Subject: CPV Vaca Station (08-AFC-11)
Response to CEC Staff Data Requests 54 through 67

Application for Certification
**Response to CEC Staff
Data Requests 54 through 67**

CPV Vaca Station

**Response to CEC Staff Data Requests
54 through 67**

FIGURE DR59-1
SINGLE-CIRCUIT 230 KV GENERATION TIE-LINE
AND SWITCHYARD ONE-LINE DIAGRAM
 CPV VACA STATION
 VACAVILLE, CA

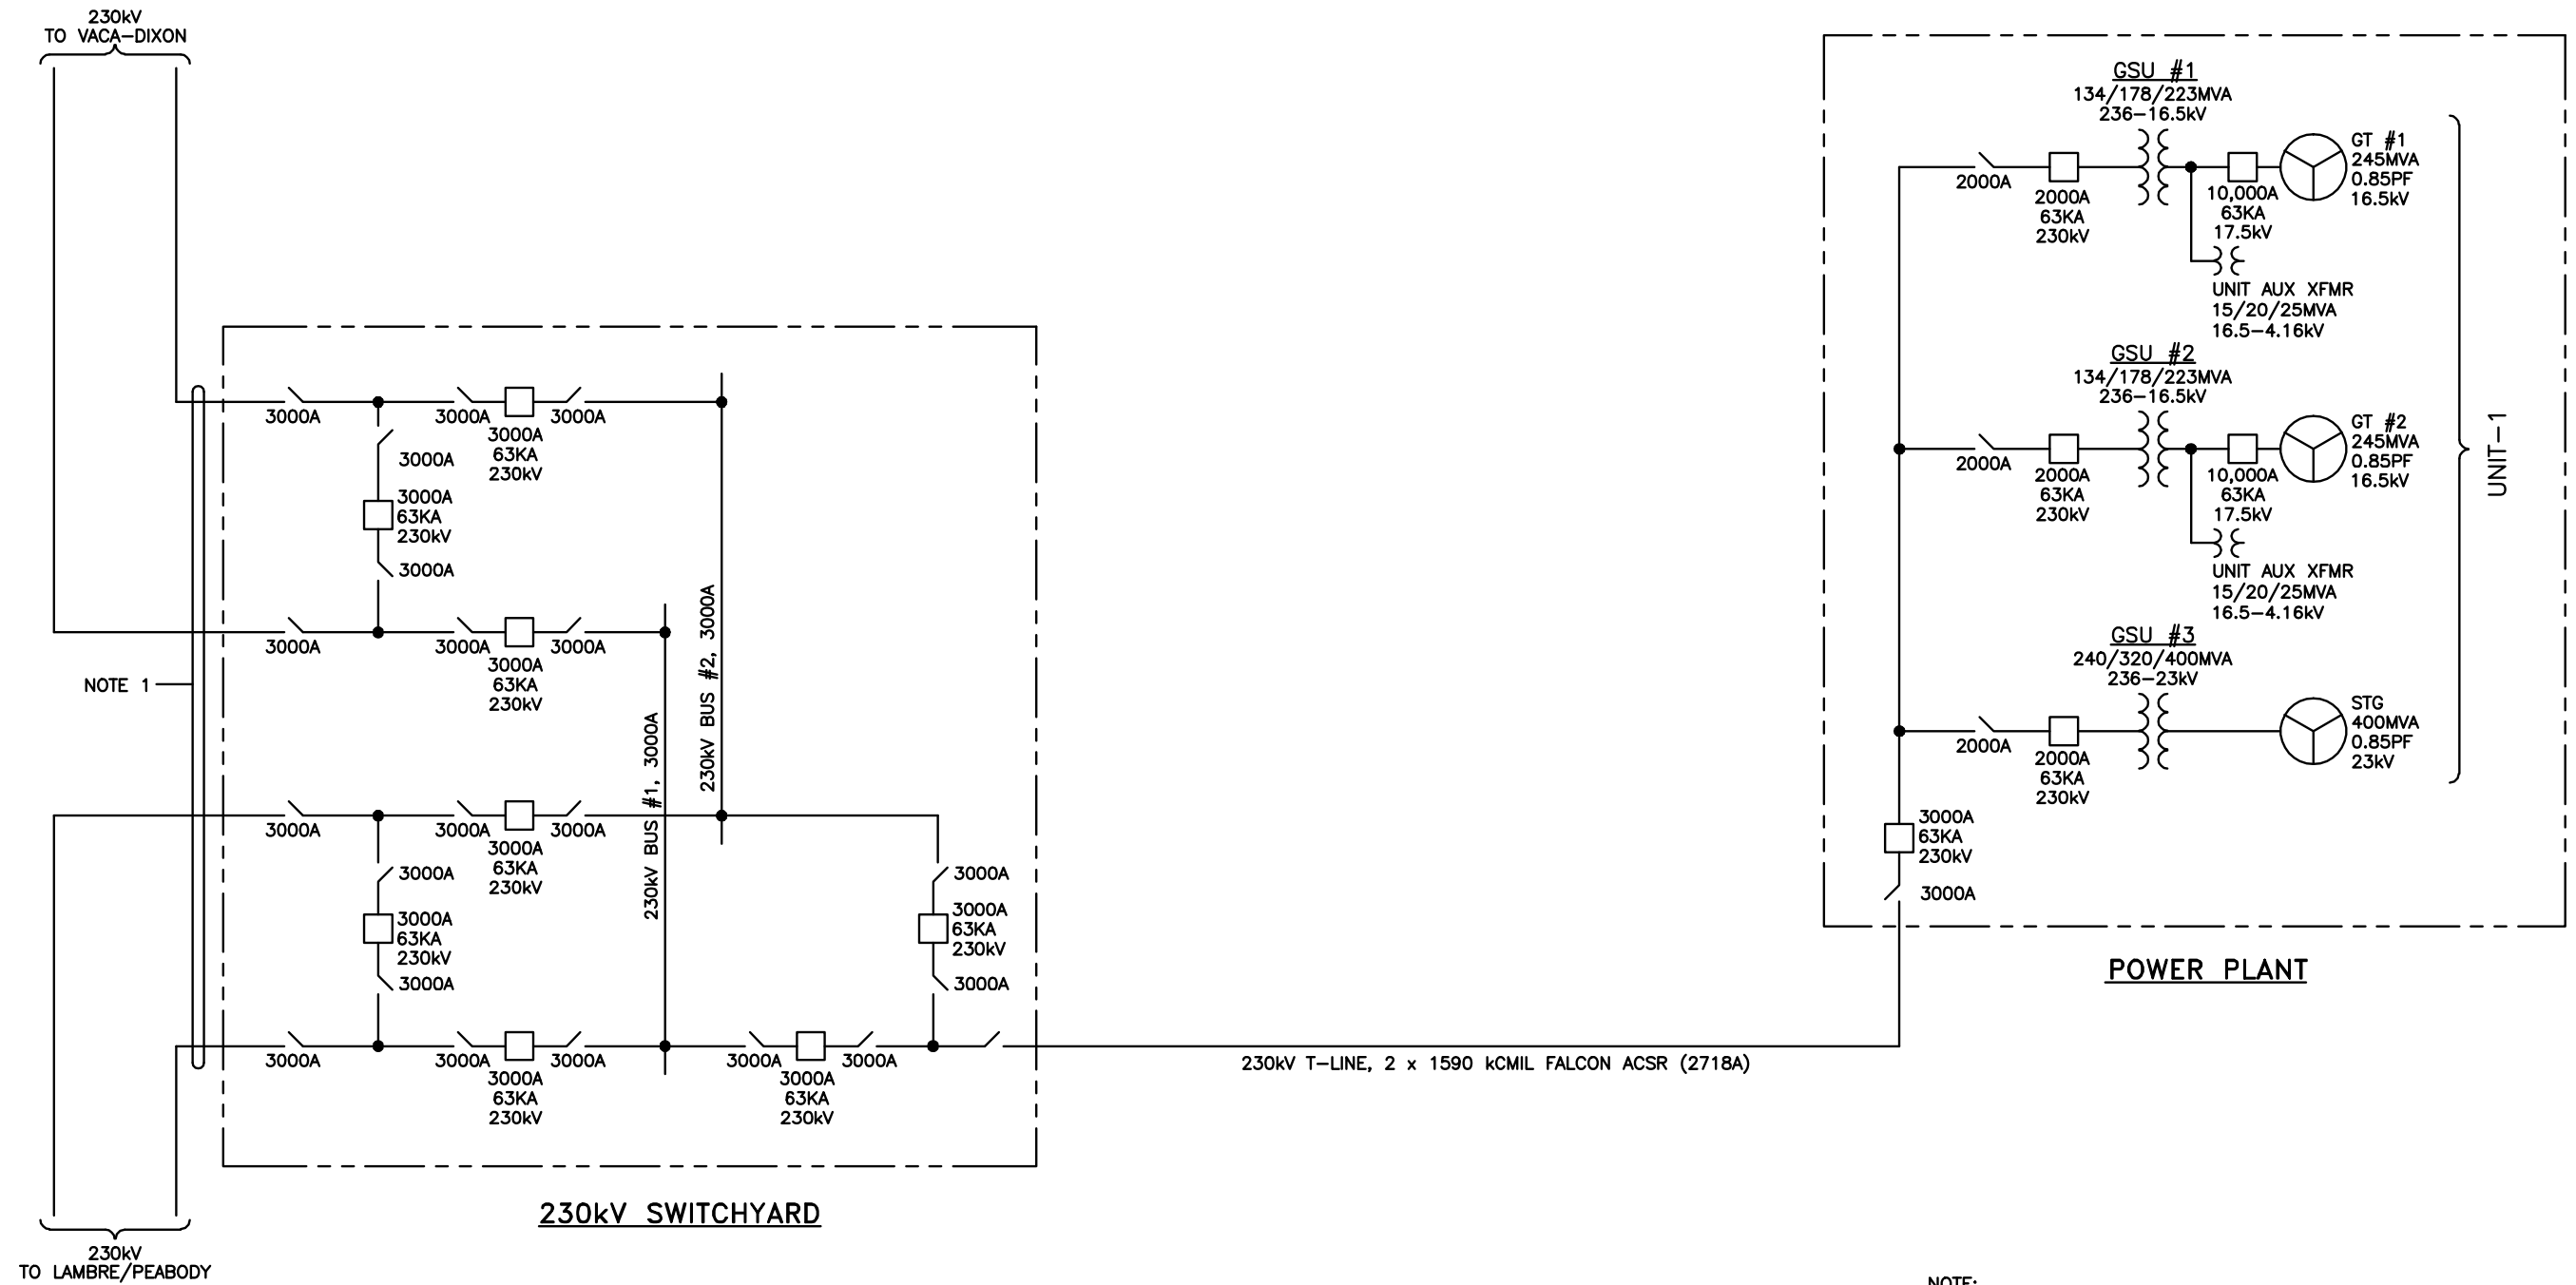
59. *Please submit an additional figure (similar to Figure DA 3.0-1), showing the single circuit generator tie-line with the associated conductor type, the current carrying capacity of the conductor, the ratings of the breakers and the disconnect switches.*

60. *Please provide all of the breakers and disconnect switches ratings for the above new figures.*

Response: See Figure DR59-1.

Response: Please see Figures DR58-1 and DR59-1.

**FIGURE DR58-1
 DOUBLE-CIRCUIT 230 KV GENERATION TIE-LINE
 AND SWITCHYARD ONE-LINE DIAGRAM**
 CPV VACA STATION
 VACAVILLE, CA

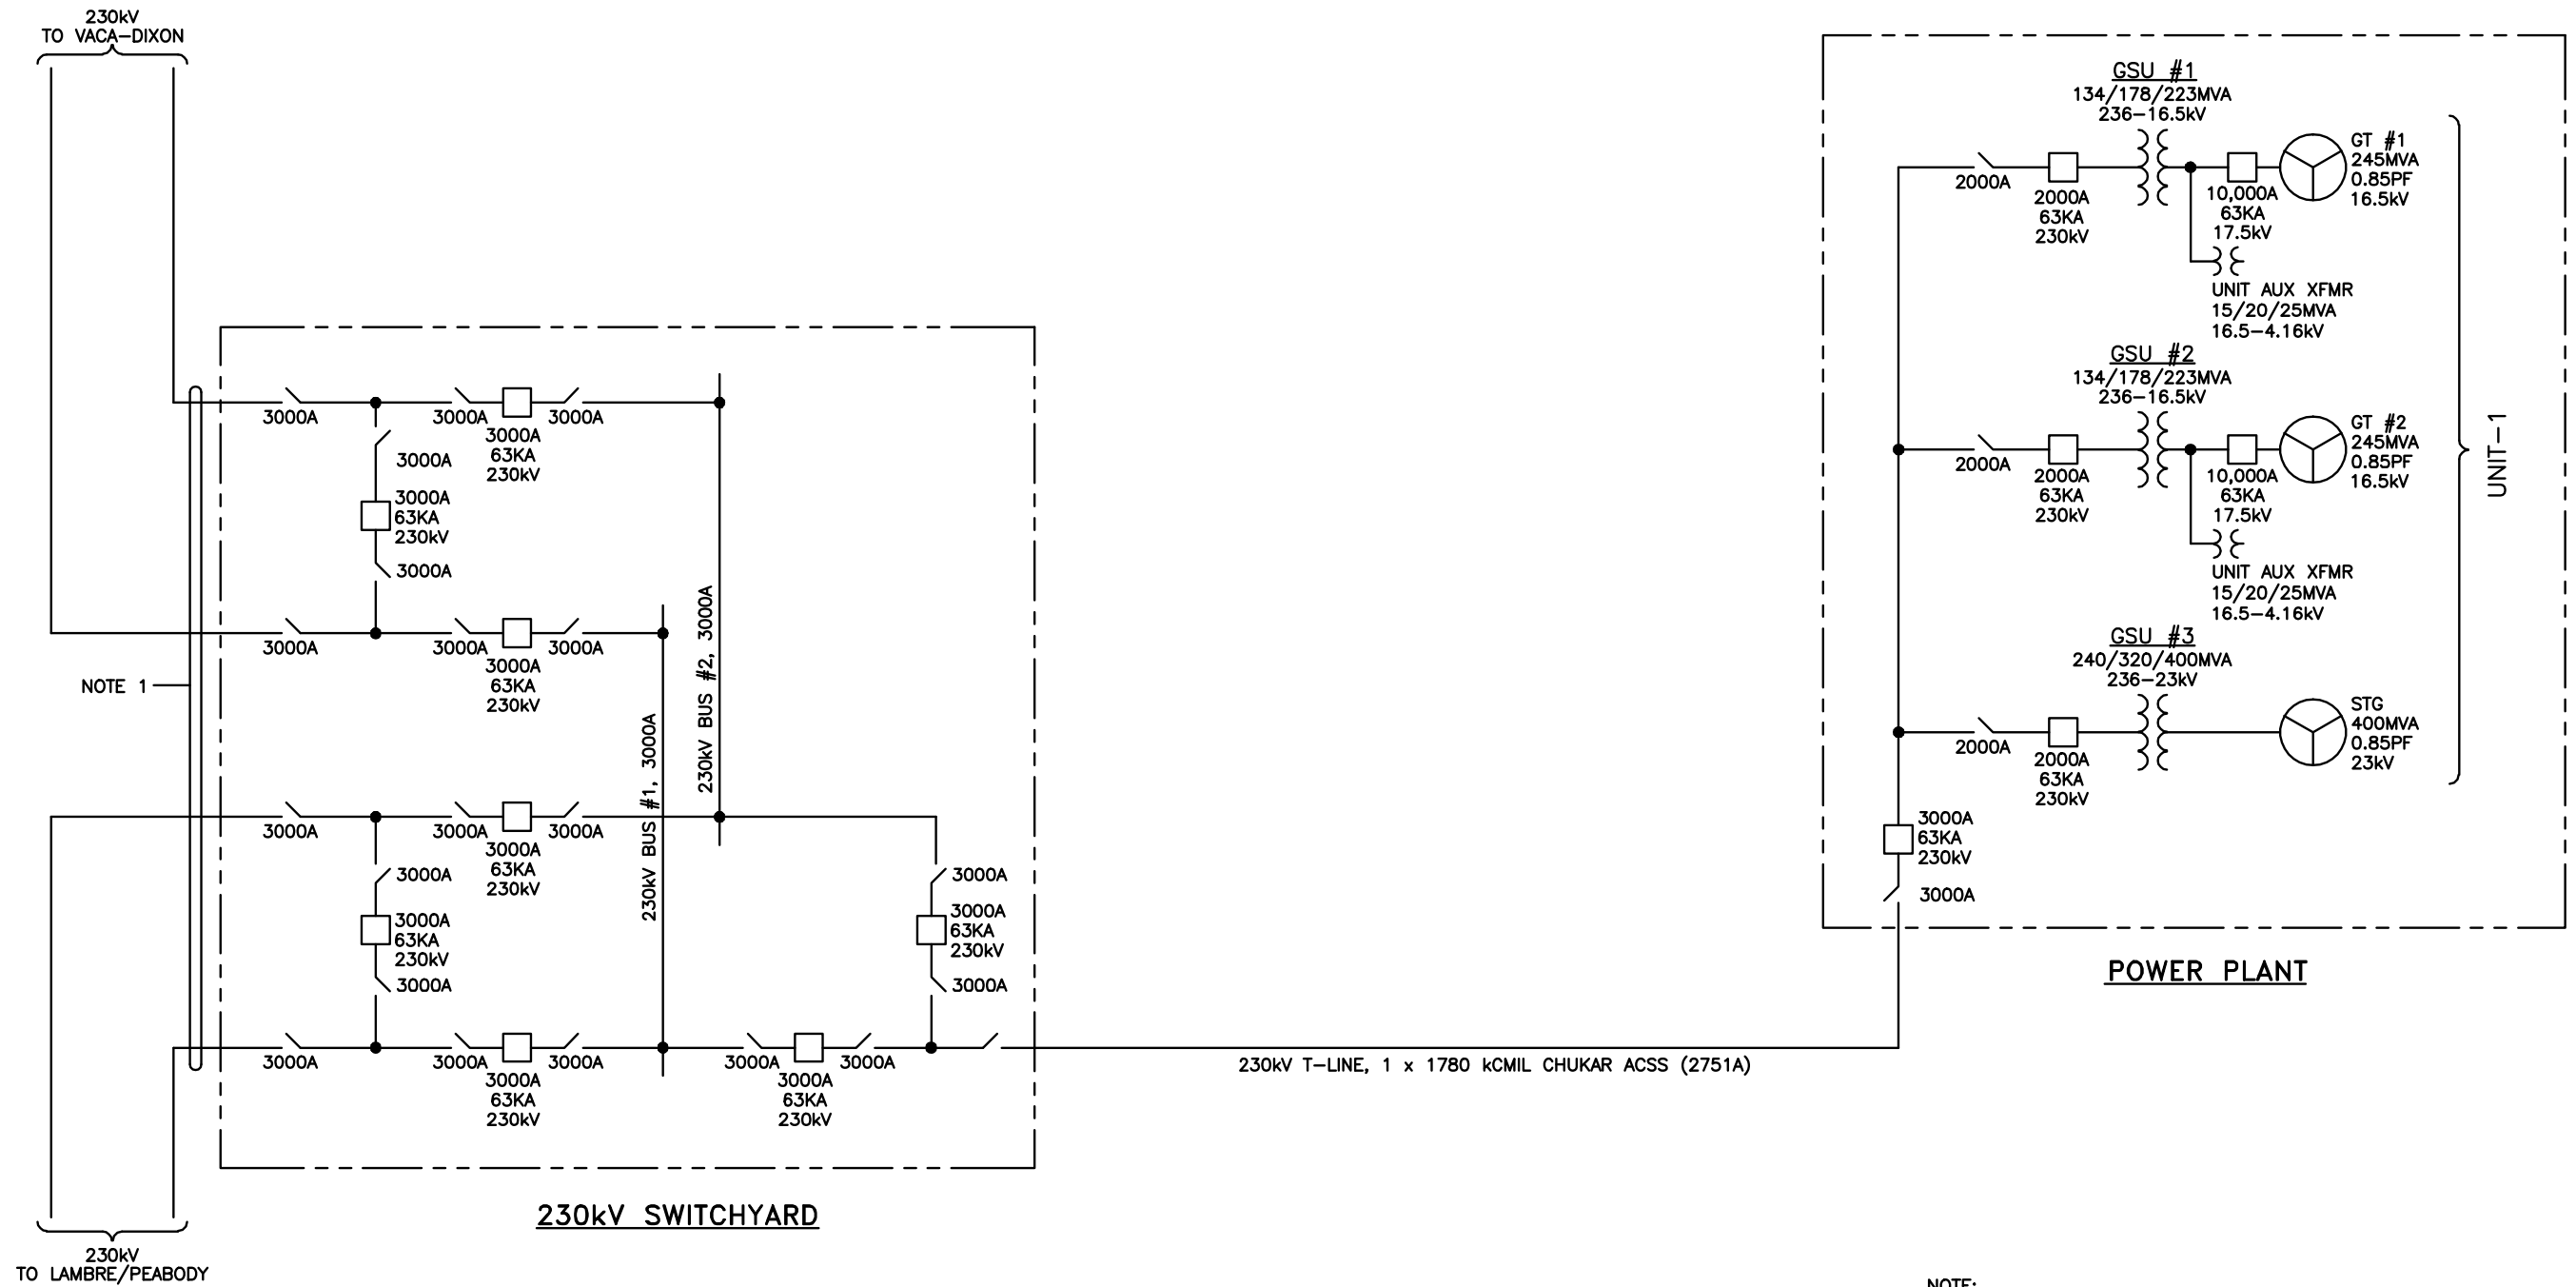
58. *Please resubmit Figure DA 3.0-1 showing the double circuit generator tie-lines with the associated conductor type, the current carrying capacity of the conductors, the ratings of the breakers and the disconnect switches.*

Response: See Figure DR58-1.

Fogging Frequency Curve for
 CPV - Vacaville, CA
 (Estimated Curve)

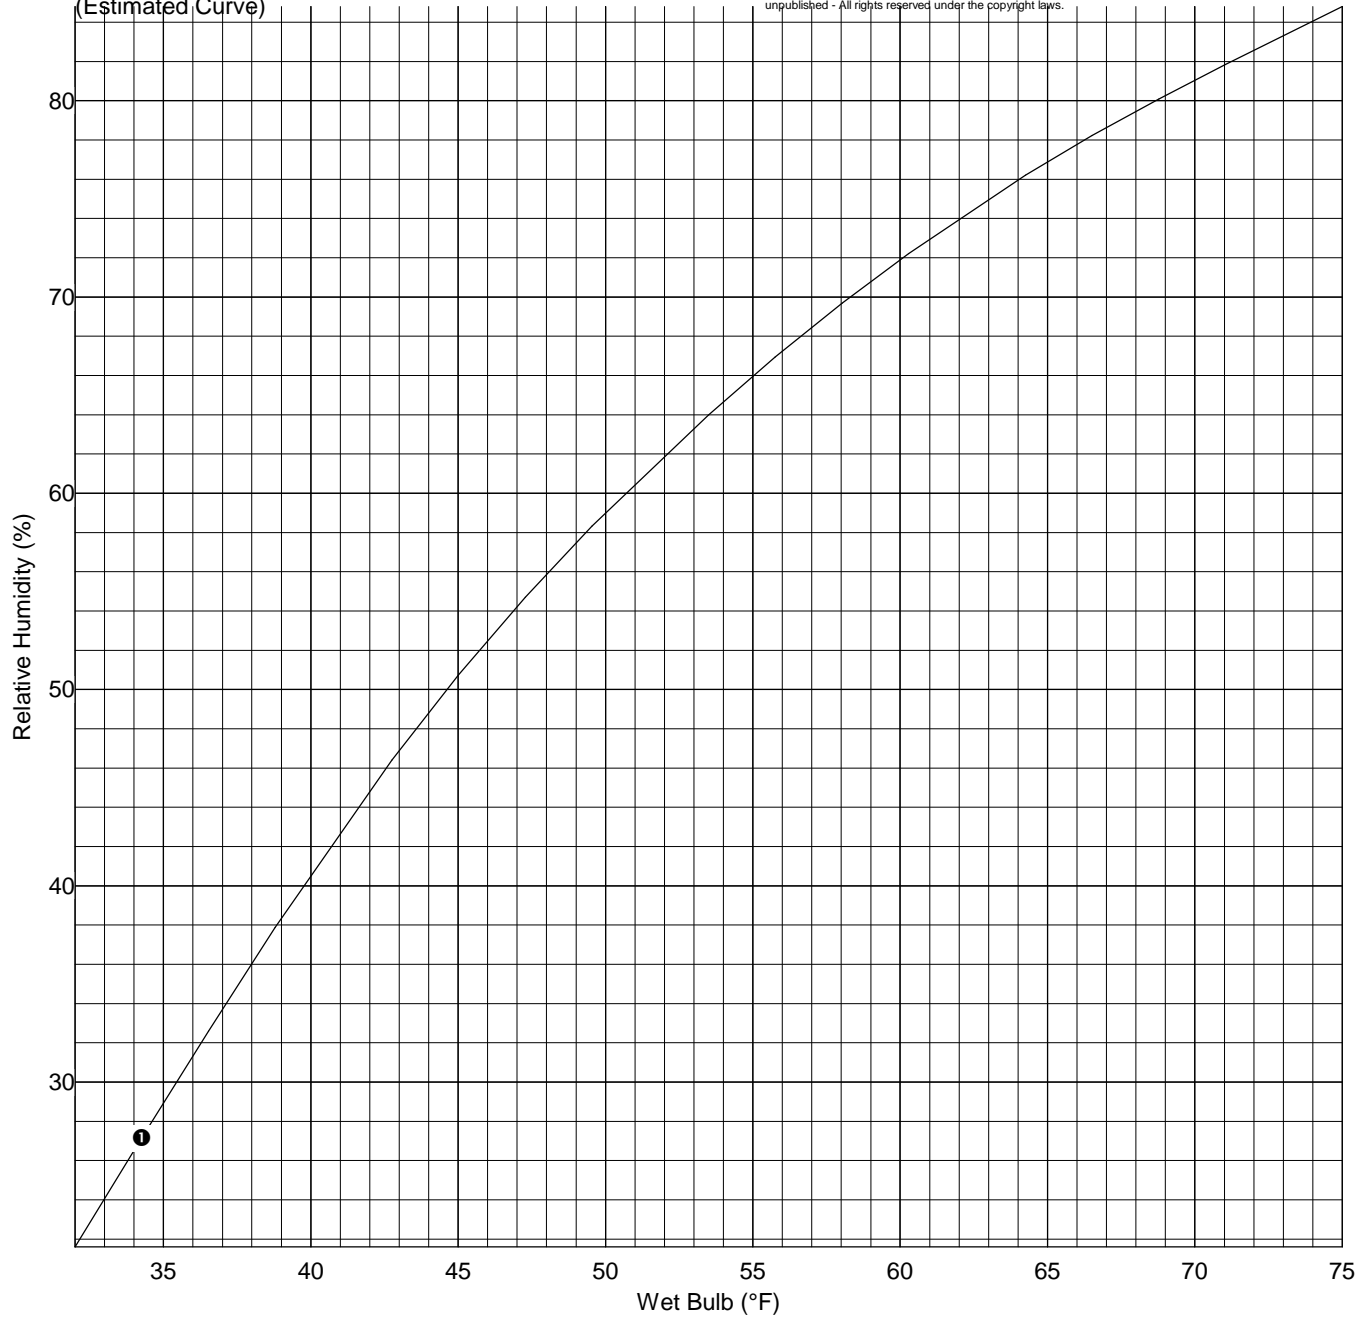
67. *Please provide the cooling tower manufacturer and model number information and a fogging frequency curve from the cooling tower vendor, if available.*

Response: The cooling tower manufacturer has not yet been selected. A representative fogging curve provided by one of the bidders is included as Attachment DR67-1.
